GEOTECHNICAL 3rd PARTY REVIEW OF
DEVELOPMENT ALTERNATIVES
PROPOSED WEST VILLAGE PROJECT
TENTATIVE TRACT 71546
CITY OF CALABASAS,
LOS ANGELES COUNTY, CALIFORNIA

March 5, 2020
(Revised March 31, 2020)

**Subject: Geotechnical 3rd Party Review of Development Alternatives
Proposed West Village Project, Tentative Tract 71546
City of Calabasas, Los Angeles County, California**

Figure 1
Existing Site Topography and Mapped Geologic Earth Units

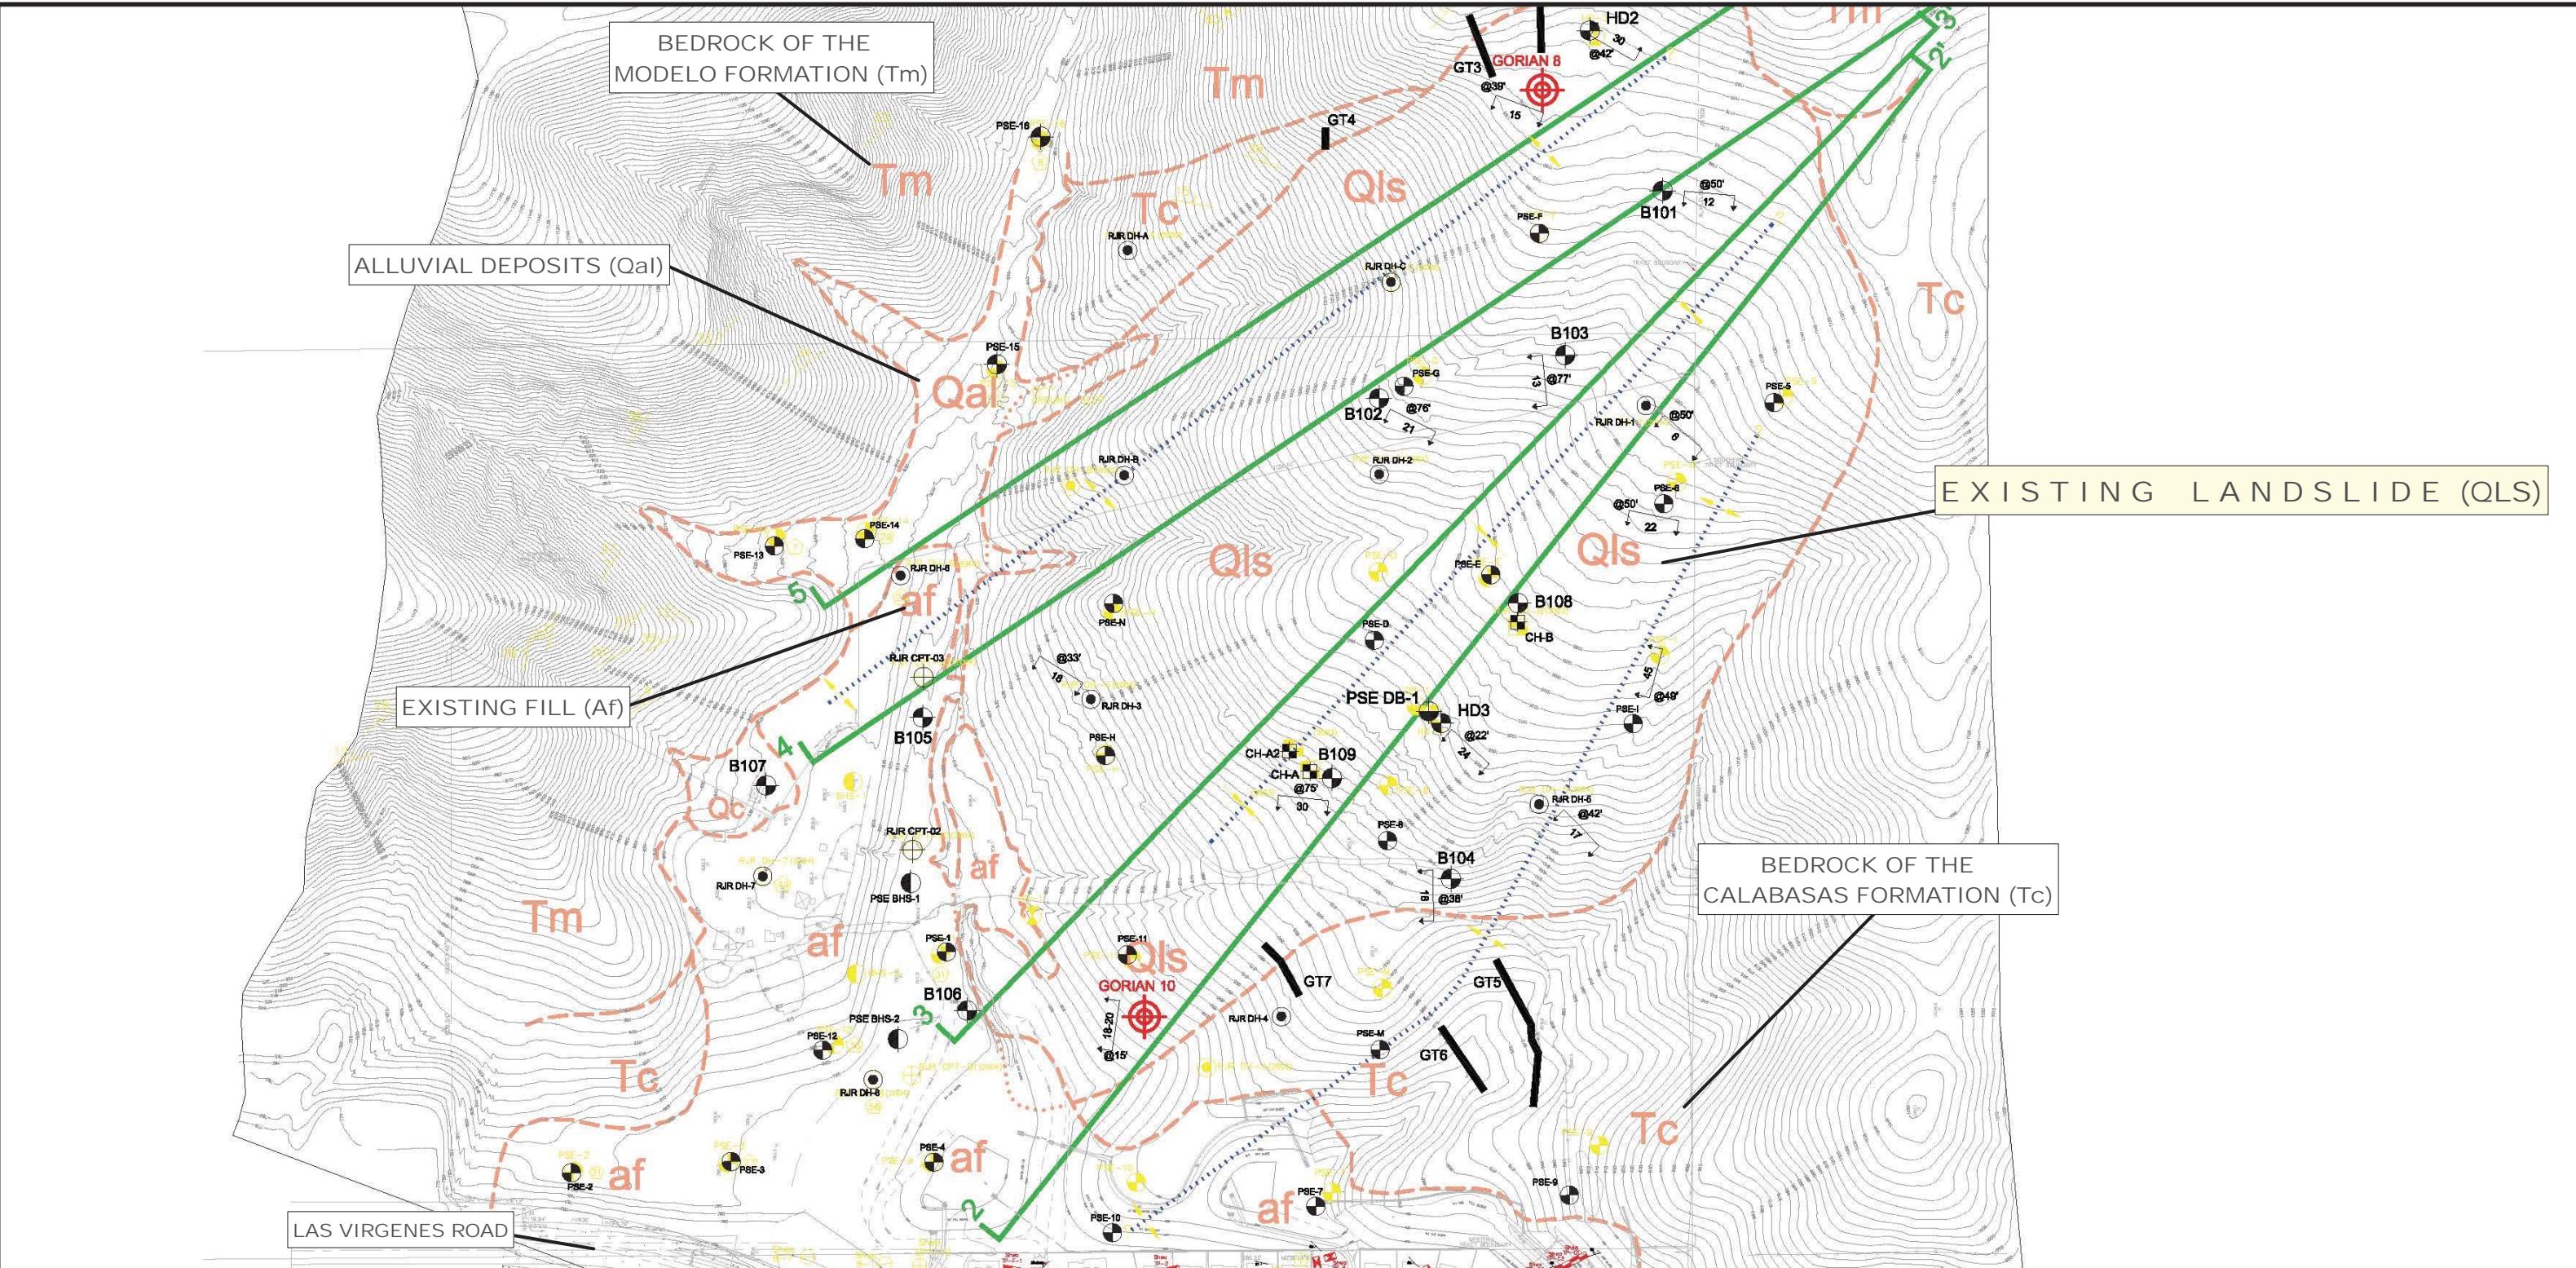
As described in the EIR, Alternative 1 consists of no development of the site. The site will remain idle and in its current condition as shown in Figure 1. As such, no mitigation will be performed to improve the stability of the mapped and documented landslide.

Evaluation of Alternative 1 included independent analysis of landslide stability based upon geotechnical cross-sections and relevant engineering parameters presented in the GWV report (2017). Slope stability analysis was conducted along Section 3-3' (Plate 3) and Section 4-4' (Plate 4) as developed by GWV. Analysis of these sections was considered to be representative of the slide mass to provide a preliminary assessment of the stability of the landslide mass as they represent the overall size and depth of the landslide. For purposes of this analysis, Section 2-2' and Section 5-5' were not analyzed as they represent lateral edge conditions of the landslide and would only be needed to detail specific, local mitigation design recommendations in that area of the landslide. Analysis indicated the calculated factor of safety was less than 1.5. Analysis under pseudostatic conditions indicated calculated factors of safety less than 1.1 corresponding to a coefficient of horizontal acceleration of 0.15. Analysis of yield acceleration indicated values of 0.09 at Section 3-3' and 0.06 at Section 4-4'. Based on the size/depth of the slide mass, displacement of the slide mass triggered by strong ground shaking is estimated to be on the order of several feet in a generally northwest (downslope) direction toward Las Virgenes Road and the adjacent residential development.

Analyses described above were based upon drained conditions, i.e., no groundwater accumulation and no pore pressure head acting upon the rupture surface of the landslide. The stability of the slide will be decreased should water levels and pore pressure head develop in the slide mass. Preliminary analysis indicated pore pressure head of 45 to 65 feet acting upon the slide plane at Section 3-3' and pressure heads of 30 to 40 feet at Section 4-4' result in a calculated factor of safety of 1.0. A factor of safety of 1.0 implies the slide mass is at a state of impending failure.

FIGURE 2
Site Plan - Current Development

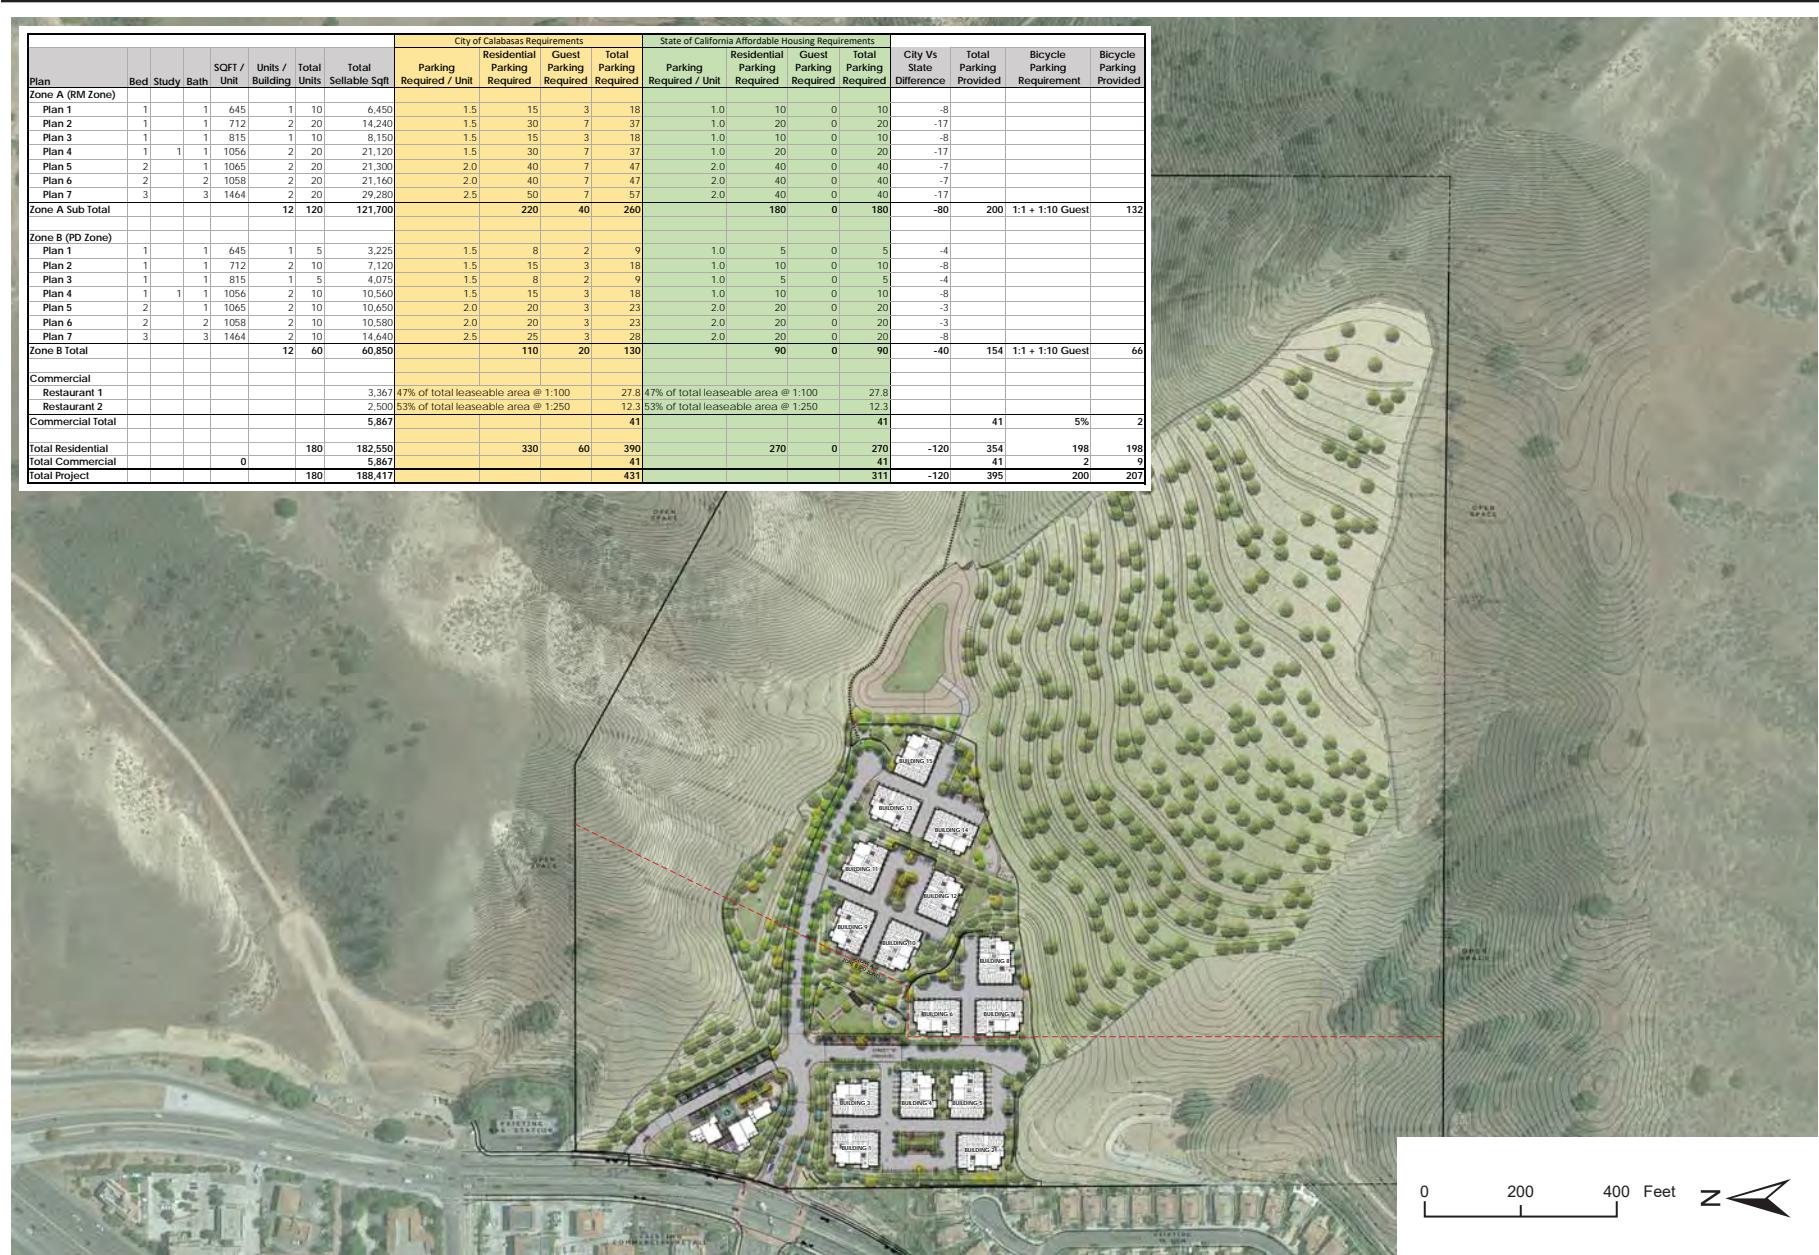
The original (2011) development was subsequently reduced in size to its currently planned layout as depicted in Figure 2 (and Plate 1 of the GWV geotechnical report, 2017). The currently proposed development (“Proposed Development”) shown in Figure

2 was reduced in size to lessen the effect of remedial grading on trees that naturally occur up slope from the development area. The current development includes fifteen multi-family homes to be distributed on three graded pads situated in a terraced configuration to conform to general site topography and one pad for construction of a commercial development. The terraced pads will be located between the proposed entry road to the west side and the ascending hillside and remnant landslide to the east. The graded pad for the commercial development will be located to the west of the access road.

Figure 4 - Section 3 - 3' Preliminary Concept - Drilled Shaft Buttress System - Alternative 4

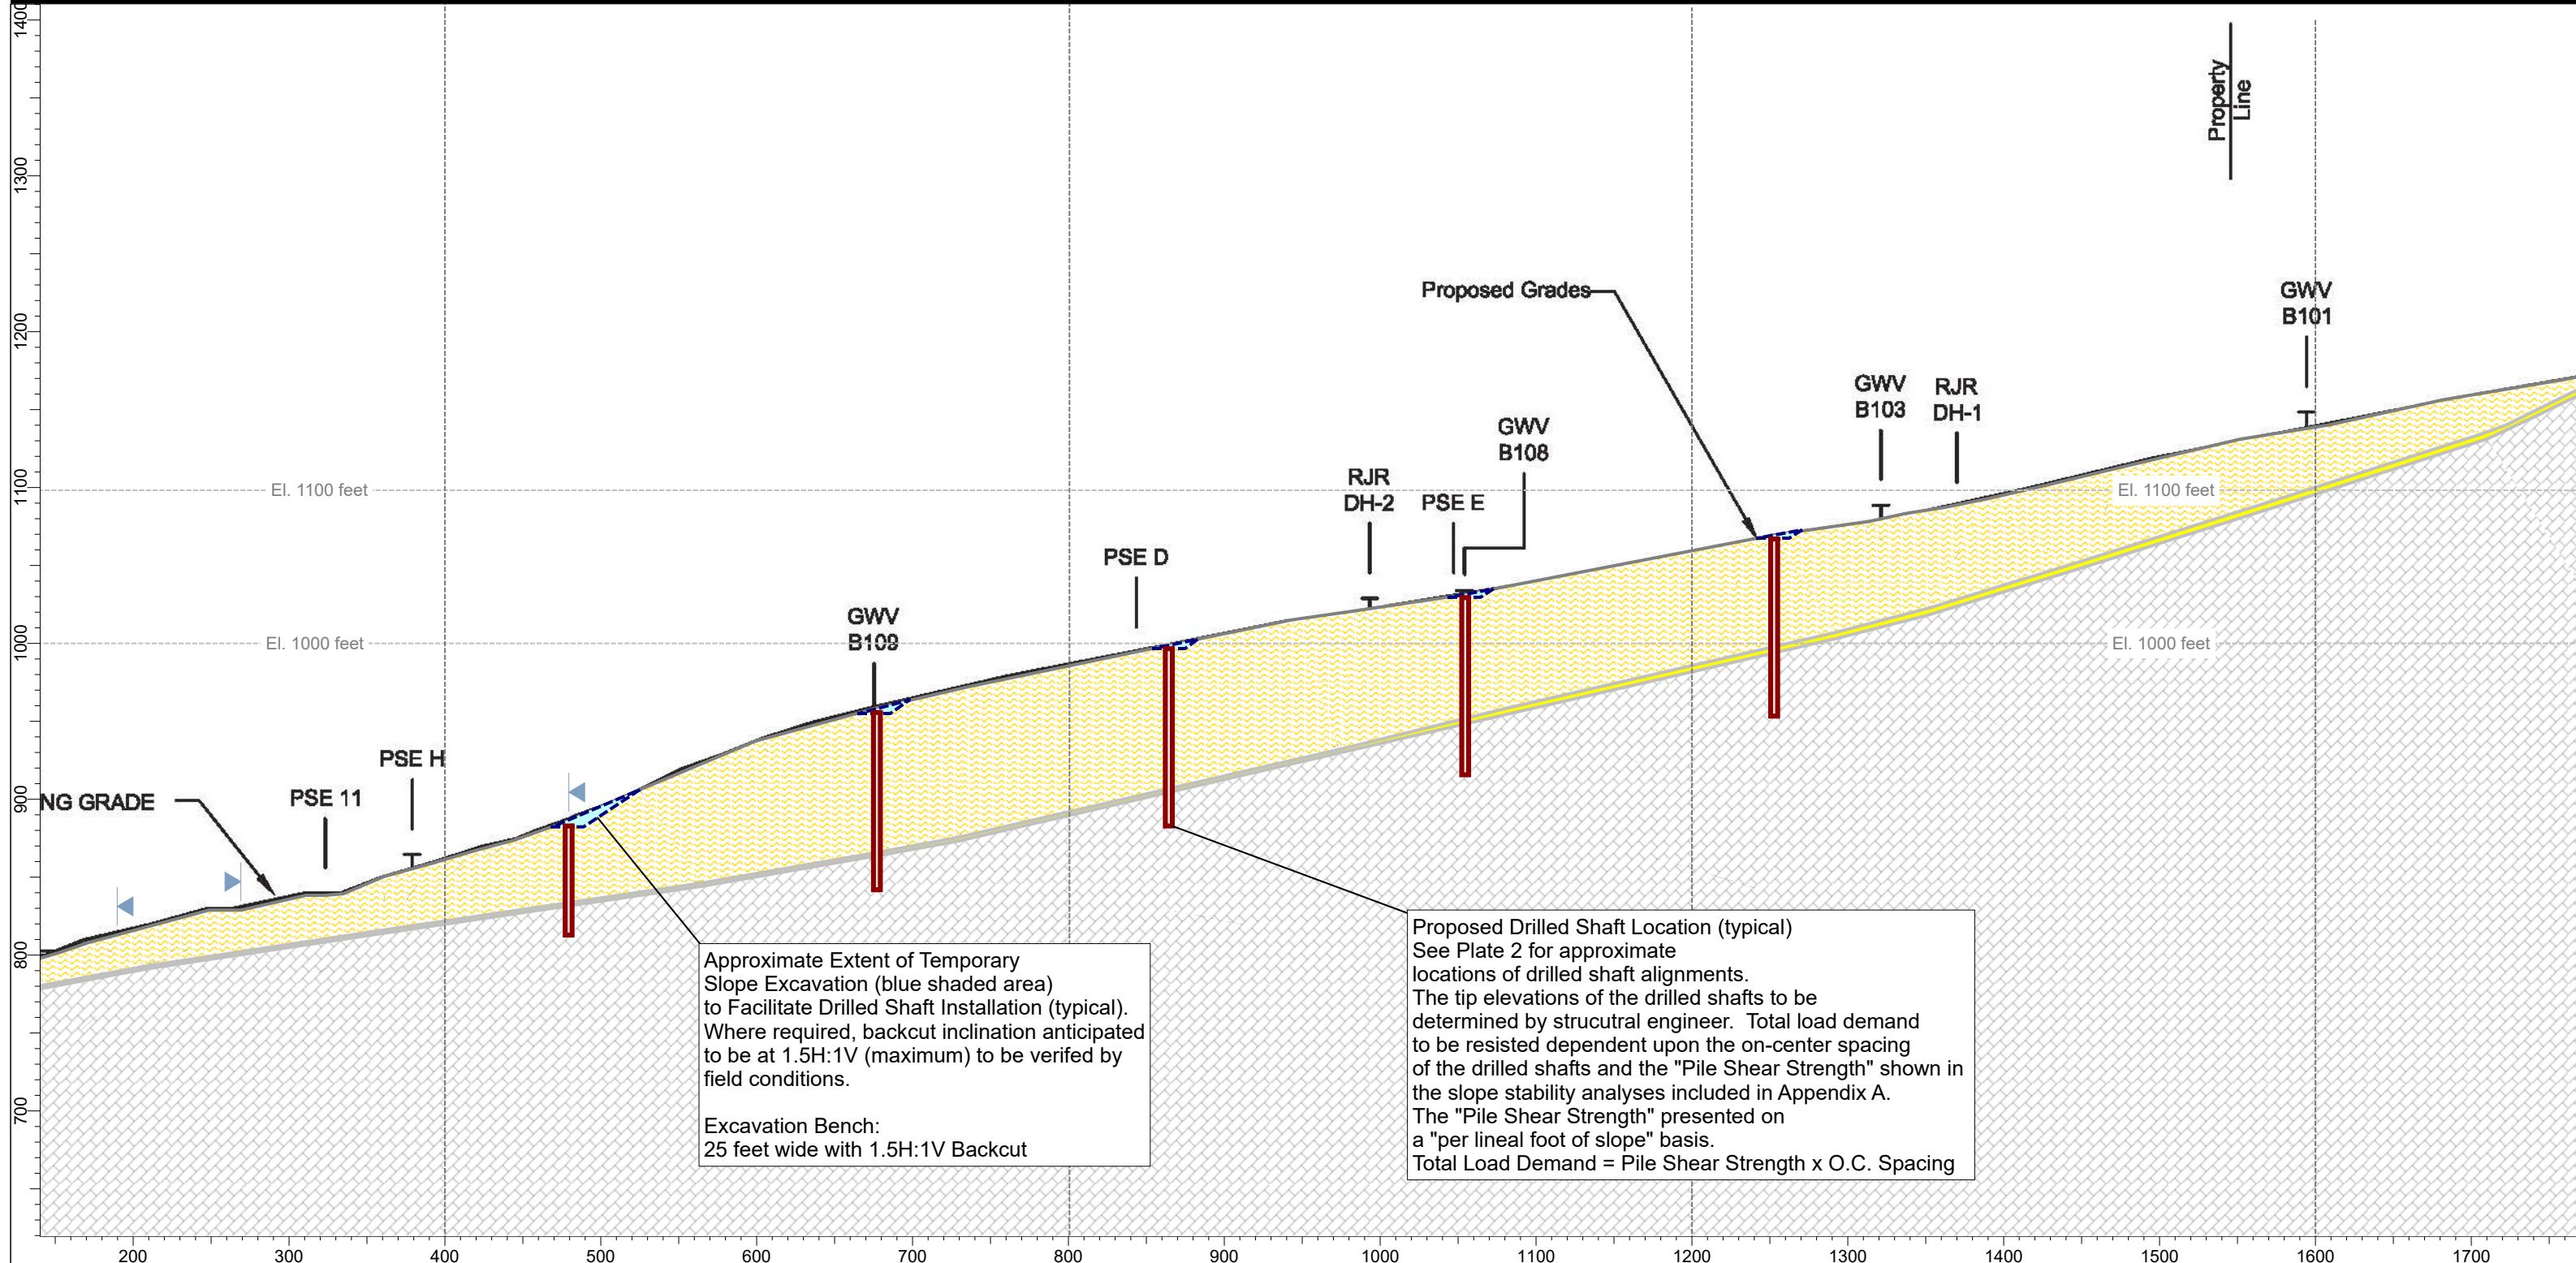
Slope stability analysis presented herein for Cross-Sections 3-3' and 4-4' (Appendix A) were performed to develop a preliminary design concept to stabilize the slope and mitigate the potential for a catastrophic event due to increase in pore pressures due to groundwater buildup and/or seismic conditions. Cross-sections 3-3' and 4-4' were selected for analysis to provide a preliminary assessment of the load demand imposed upon a drilled shaft buttress system since these sections were located in the central region of the slide where the depth to the slide mass and the load demand are greatest. The analyses indicate multiple rows of drilled shafts (see Plate 2) extending up the slope well beyond the limits of development will be necessary to develop a mechanical buttress system and achieve the minimum required factors of safety for gross stability and seismic stability of the site. This method of mitigation will not prevent surficial failures from occurring and impacting the site. The load demand combined with the number of reinforcing elements that will be necessary is expected to reduce the feasibility of this alternative. Although we cannot estimate the cost of such a design, our experience suggests this type of design would likely be deemed not financially viable and is not free of risk from surficial instability.

Figures 4 and 5 (and Plates 5 and 6) are based upon the geologic Cross-Sections 3-3' and 4-4'. As discussed previously for Alternative 1, these sections were selected for analysis since they represent the greatest depths to the slide plane and, as a result, the greatest load demand on the buttress system. These figures and plates show the locations in which drilled shafts will be required to achieve the desired calculated factors of safety. The approximate limits of temporary cuts (i.e., benching and backcuts) to facilitate construction of the drilled shaft buttress system are shown based upon the preliminary design developed for these cross-sections. These figures are intended to provide a conceptual view of the temporary earthwork that is likely to be necessary for drilled shaft construction.

Based on a review of the plans and on the interpreted geologic conditions, both the originally proposed Alternative 4 design and the subsequently proposed modification to Alternative 4 (i.e., the drilled shaft buttress system) are not favorable options because they do not mitigate all the potential landslide hazards that may impact the proposed development and do not provide the same level of assurance that neither the project site nor nearby development would be adversely impacted by the landslide hazard as the subject project and Alternatives 2, 3, and 5. Therefore, we do not recommend Alternative 4 for the subject site because the landslide hazard mitigation proposed for the subject project and Alternatives 2, 3 and 5 includes known, reliable mitigation options that are more comprehensive in their mitigation of the landslide hazard.

We conclude that Alternative 1 poses a low risk to adjacent improvements, though long-term maintenance would be necessary. For the original design of Alternative 4 and its modified design as presented by Leighton, we do not recommend reliance on a buffer zone coupled with the proposed drilled shaft buttress system due to the lack of sufficient data for each proposed elemental segment and in consideration of an unnecessarily high risk mitigation option so close to a known complex landslide hazard. The proposed system is uncommon and relatively untested and does not address all potential landslide conditions.
